<b>Title - Sujet</b> CCGC Mechanical and Sprinklers	
<b>Solicitation No. - N° de l'invitation</b> EB144-190543/A	<b>Amendment No. - N° modif.</b> 008
<b>Client Reference No. - N° de référence du client</b> EB144-19-0543	<b>Date</b> 2018-08-14
<b>GETS Reference No. - N° de référence de SEAG</b> PW-\$PWA-121-5750	
<b>File No. - N° de dossier</b> PWA-8-80020 (121)	<b>CCC No./N° CCC - FMS No./N° VME</b>
<b>Solicitation Closes - L'invitation prend fin</b> <b>at - à 02:00 PM</b> <b>on - le 2018-08-21</b>	<b>Time Zone</b> <b>Fuseau horaire</b> Atlantic Daylight Saving Time ADT
<b>F.O.B. - F.A.B.</b> <b>Plant-Usine:</b> <input type="checkbox"/> <b>Destination:</b> <input checked="" type="checkbox"/> <b>Other-Autre:</b> <input type="checkbox"/>	
<b>Address Enquiries to: - Adresser toutes questions à:</b> Russell (PWA), Alex	<b>Buyer Id - Id de l'acheteur</b> pwa121
<b>Telephone No. - N° de téléphone</b> (902) 401-8180 ( )	<b>FAX No. - N° de FAX</b> (902) 496-5016

**ADDENDUM NO. 2**

**Item 3.1 DRAWING 01-MC-101 CONTROLS – CABOT - SCHEMATICS**

Reference Drawing: 05-MDV-101

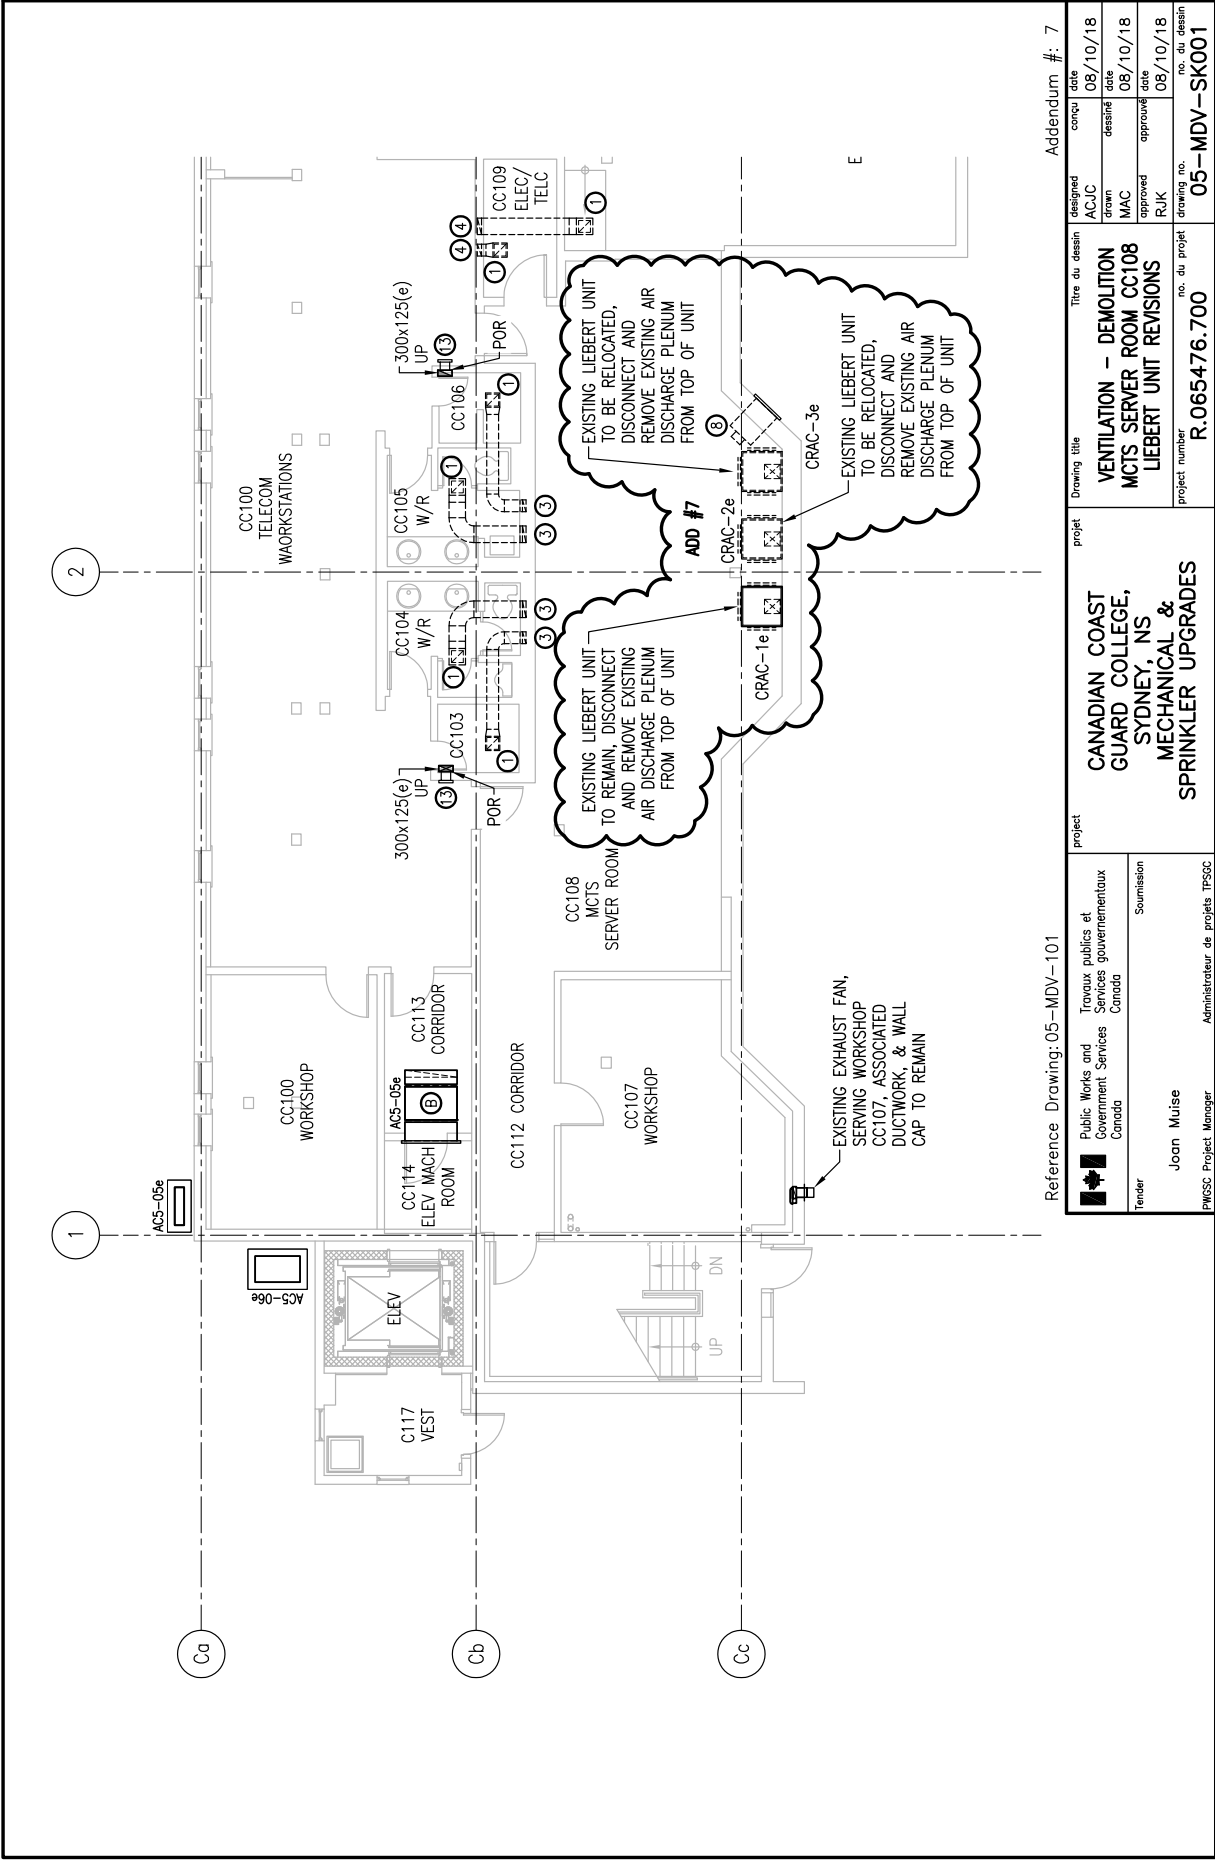
**Item 3.45      DRAWING 05-MDV-101 VENTILATION – TELC/MCTS LEVEL 100 – 200 DEMOLITION**

- .1      Revise the drawing as per the attached Sketch 05-MDV-SK001 (This Addendum).

Reference Drawing: 05-MH-101

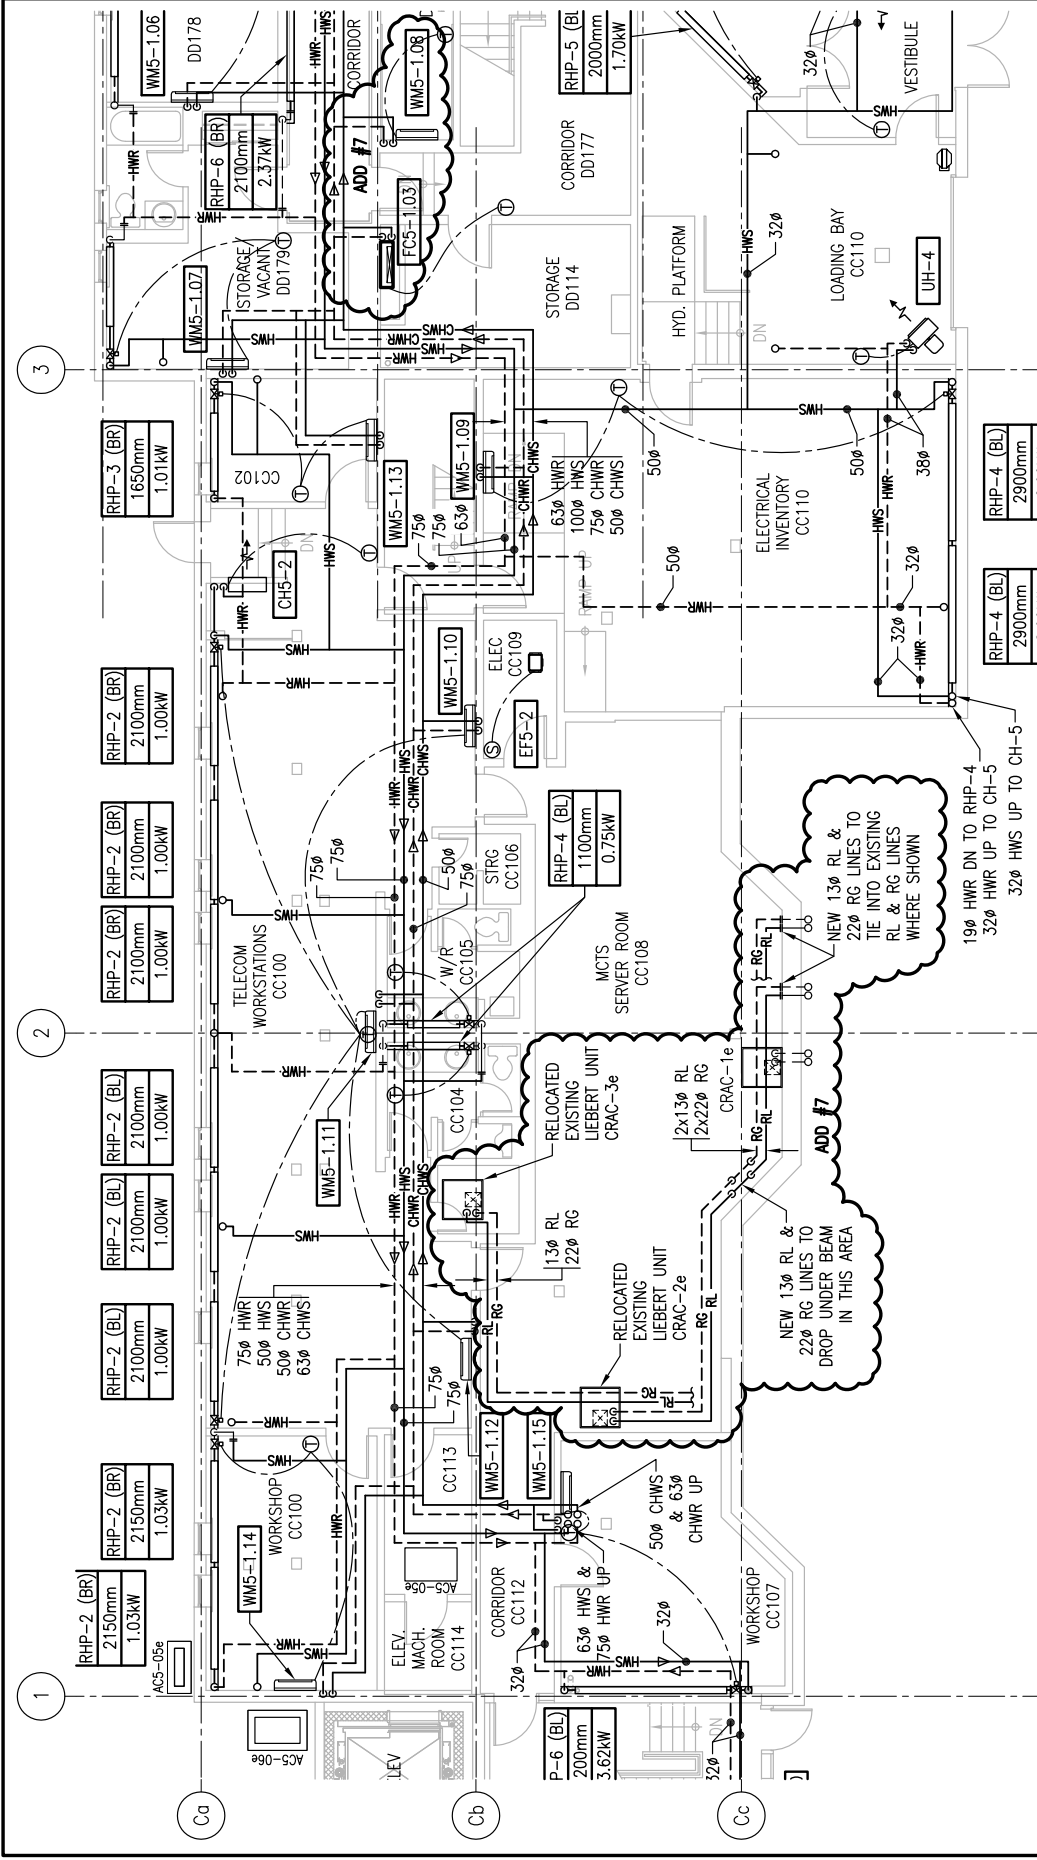
**Item 3.47      DRAWING 05-MH-101 HVAC PIPING – TELC/MCTS – LEVEL 100 – 200 NEW WORK**

- .1      Revise the drawing as per the attached Sketch 05-MH-SK001(This Addendum).
- .2      Level 100 – Remove RL and RG piping shown between WM5-1.08 (MacKenzie) and existing Condensing Unit AC5-06e. Provide new 19mm CHWS & CHWR branch lines to serve WM5-1.08 from 50mm CHWS & 75mm CHWR lines running above corridor ceiling.
- .3      Level 100 – Provide new CHWS & CHWR branch lines to serve ducted fan coils FC4-1.03 from CHWS & CHWR lines running above corridor ceiling.
- .4      Level 200 – Provide new CHWS & CHWR branch lines to serve ducted fan coils FC4-2.01, FC4-2.02, FC4-2.03, & FC4-2.04 from CHWS & CHWR lines running through level 200 corridor ceiling.

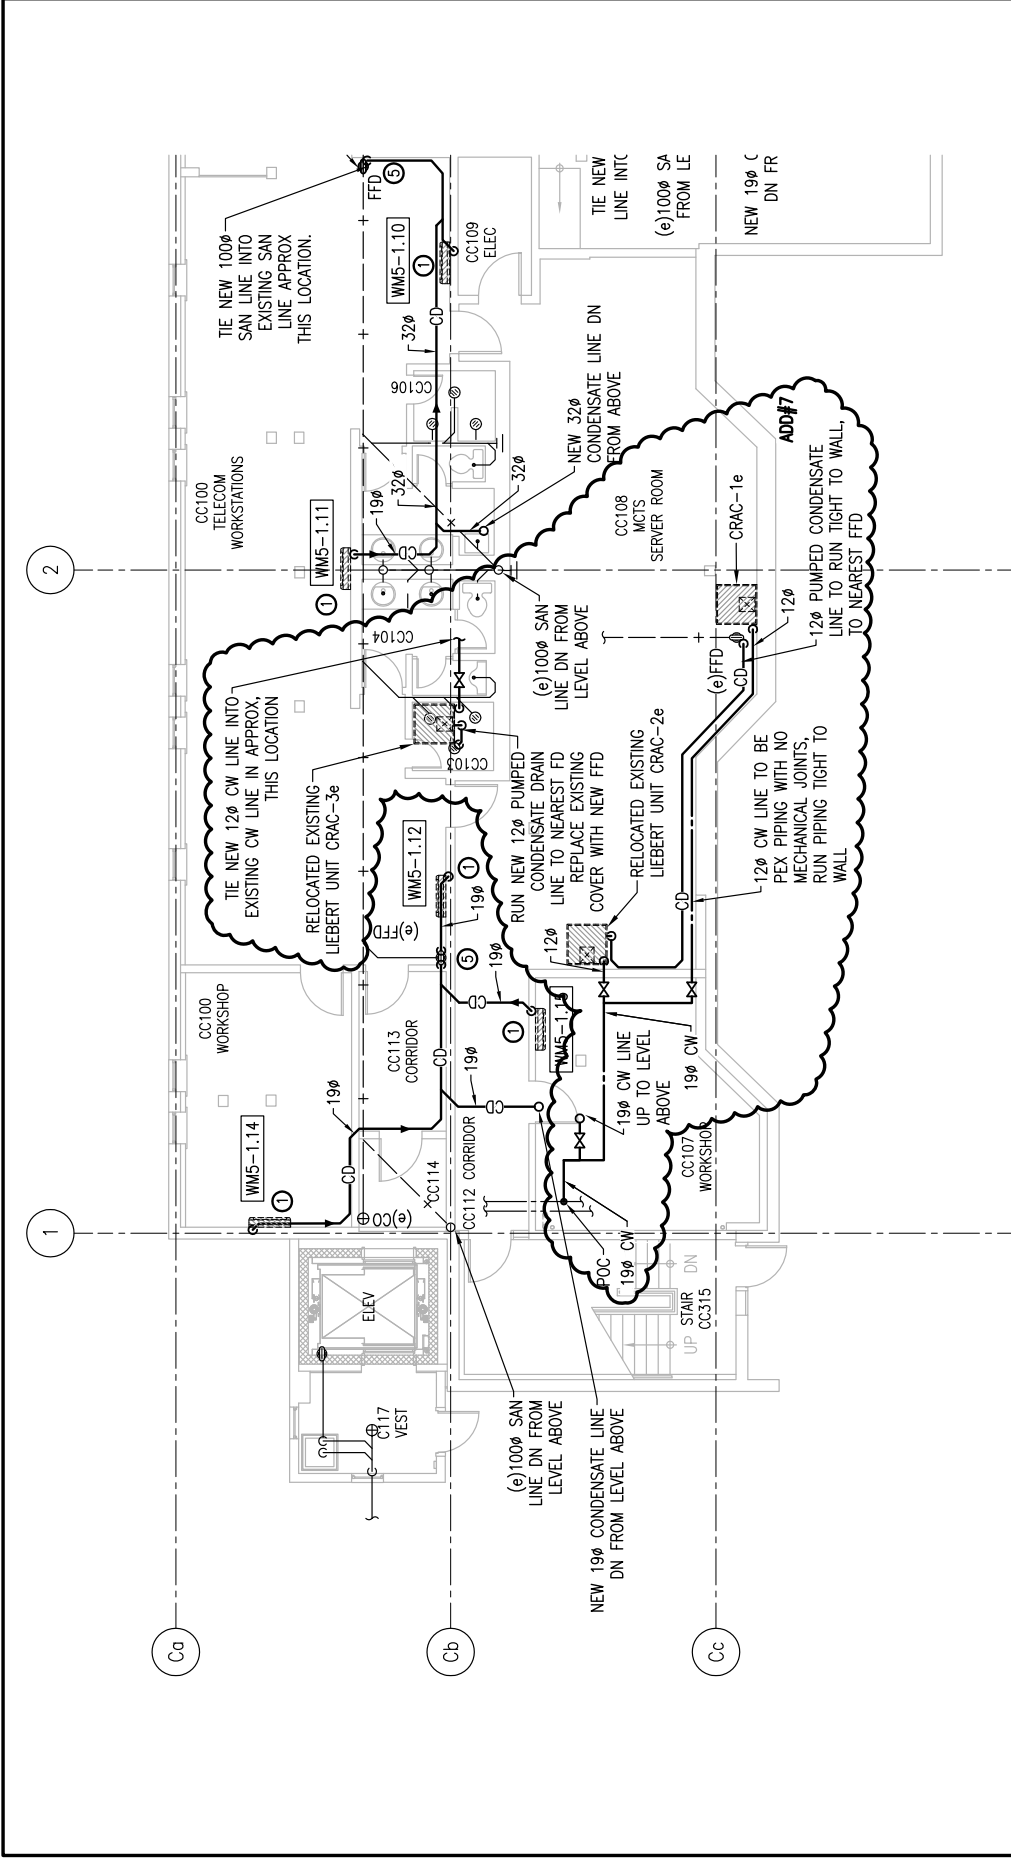
**Item 3.50      DRAWING 05-MP-101 PLUMBING – TELC/MCTS – LEVEL 100 – 200 NEW WORK**

- .1      Revise the Drawing as per the attached Sketch 05-MP-SK002 (This Addendum).

Reference Drawing: 05-MV-301

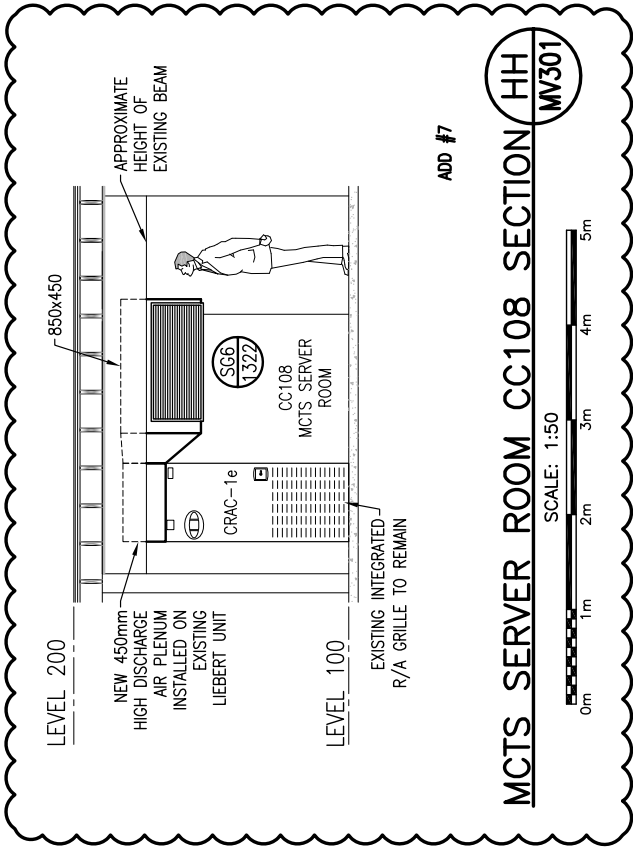
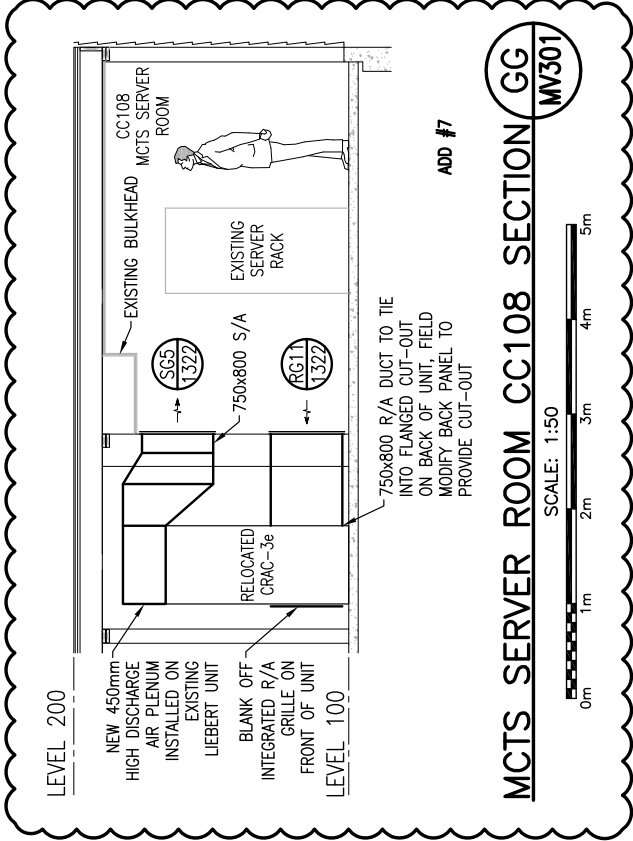
**Item 3.54      DRAWING 05-MV-301 VENTILATION – TELC/MCTS/MACKENZIE SECTIONS**

- .1      Revise the drawing as per the attached Sketch 05-MV-SK002 (This Addendum).

Reference Drawing: 06-MH-502

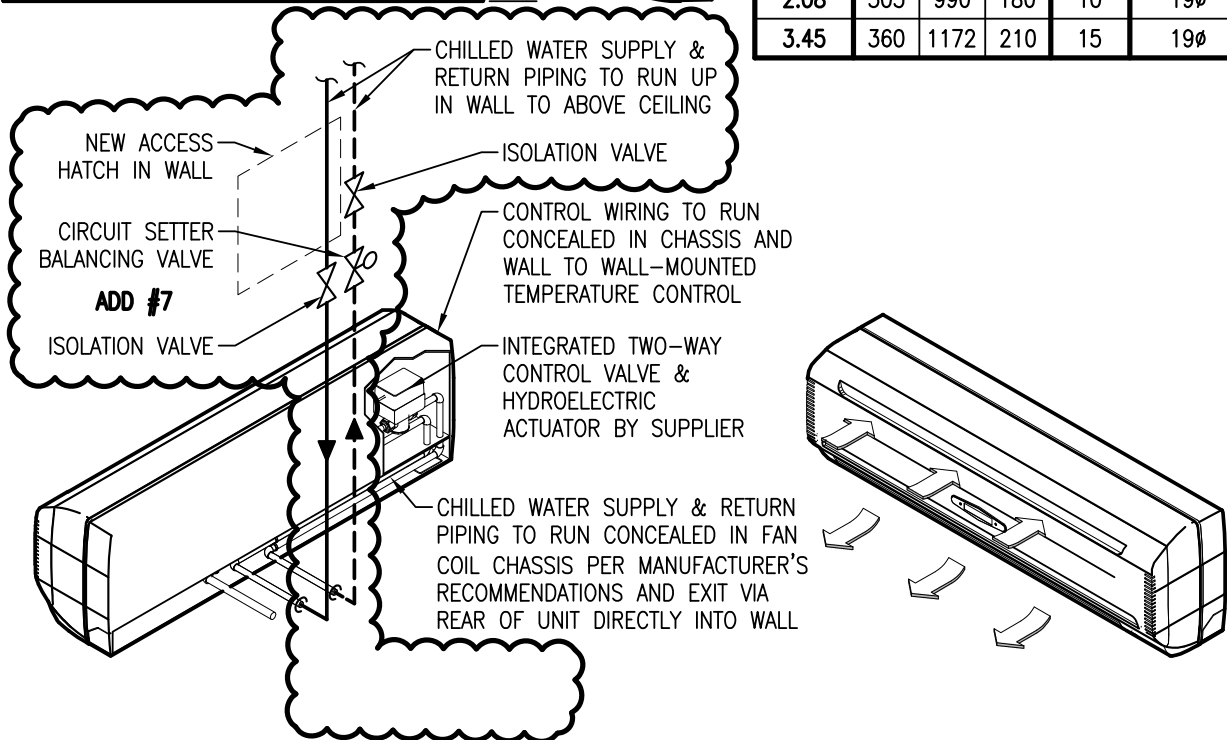
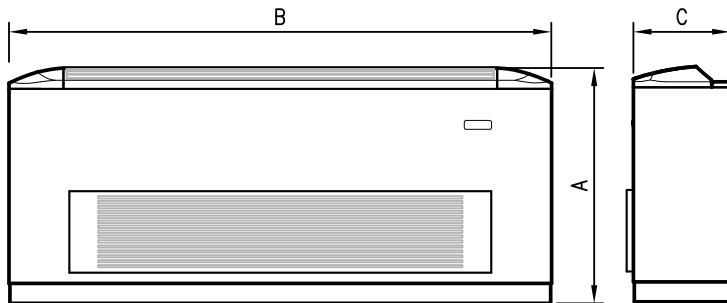
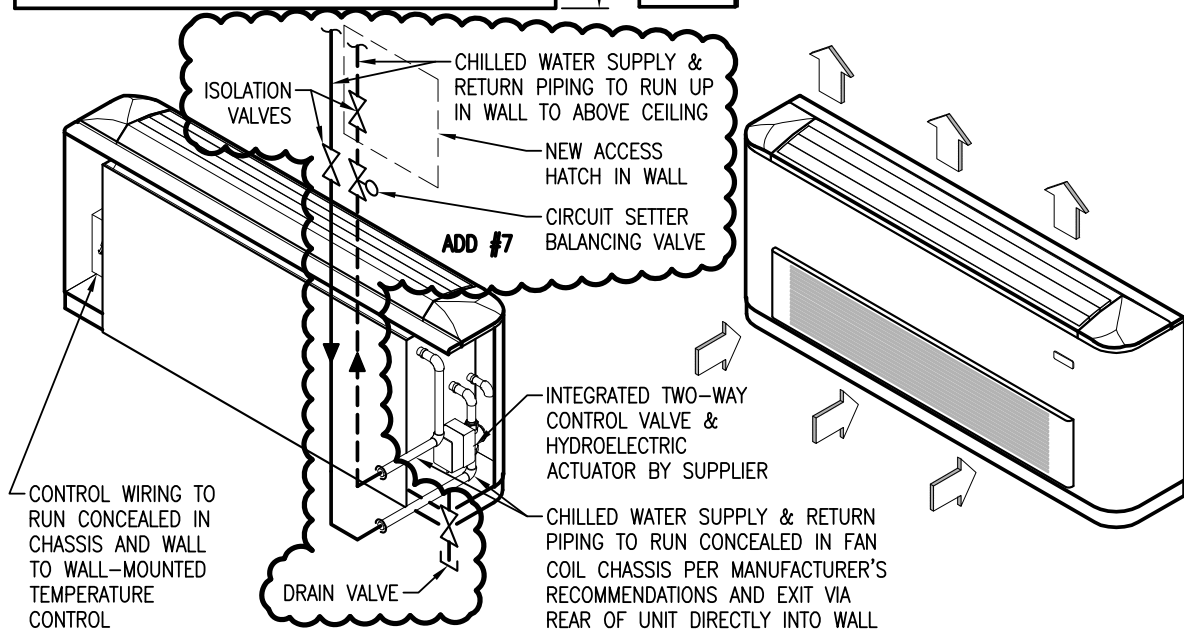
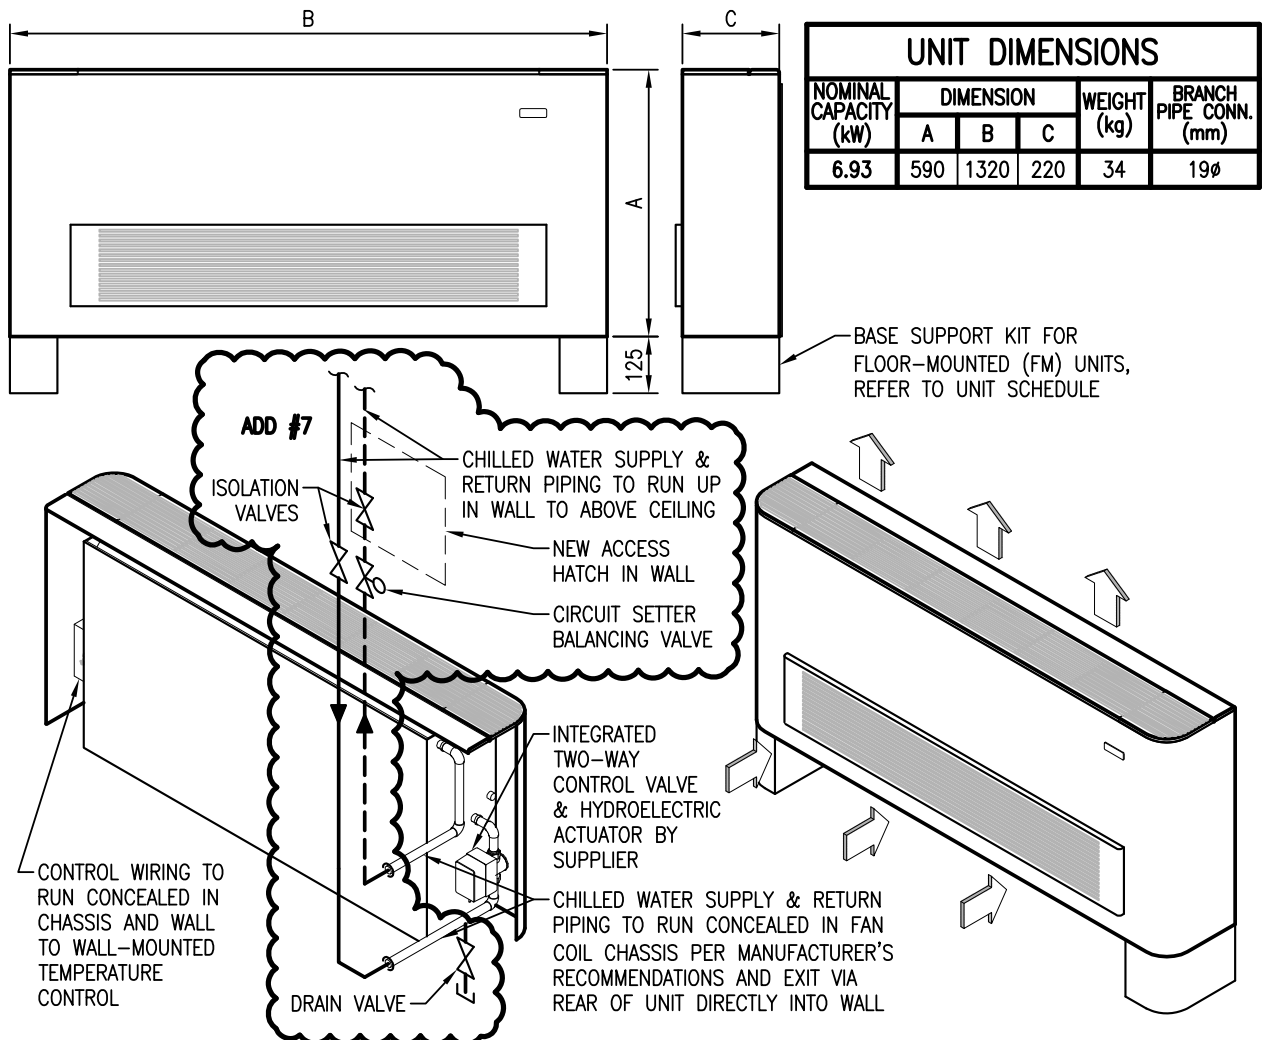
**Item 3.57      DRAWING 06-MH-502 ALERT HVAC PIPING DETAILS**

- .1      Revise Detail 7 of this drawing per Sketch 06-MH-SK004 HVAC Piping Wall Mounted Fan Coil Detail Revisions dated 2018-08-10 (This Addendum).

- .2 Revise Detail 8 of this drawing per Sketch 06-MH-SK005 HVAC Piping Wall Mounted Fan Coil Detail Revisions dated 2018-08-10 (This Addendum).
- .3 Revise Detail 9 of this drawing per Sketch 06-MH-SK006 HVAC Piping Wall Mounted Fan Coil Detail Revisions dated 2018-08-10 (This Addendum).
